DeltaPSU Product Notice

Open Frame PJT-40W & MDS-040APS Series Product Upgrade Notice

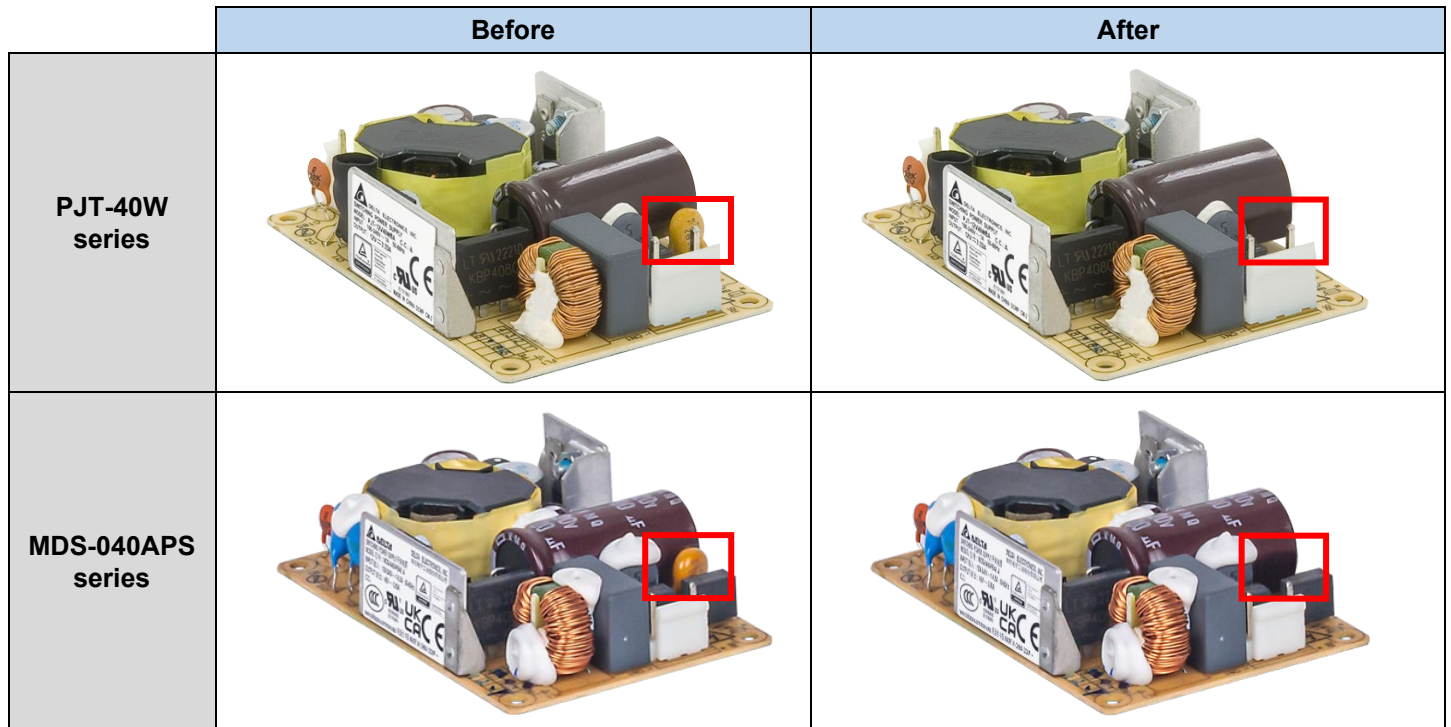
In order to upgrade to the latest IEC 62368-1:2018 (Ed 3.0) standards, Delta will remove the varistor component (position "Z1") from the PJT-40W and MDS-040APS series. Comprehensive testing and verification of the results have been conducted to ensure that all customers can expect consistent, high-quality product performance after these design changes.
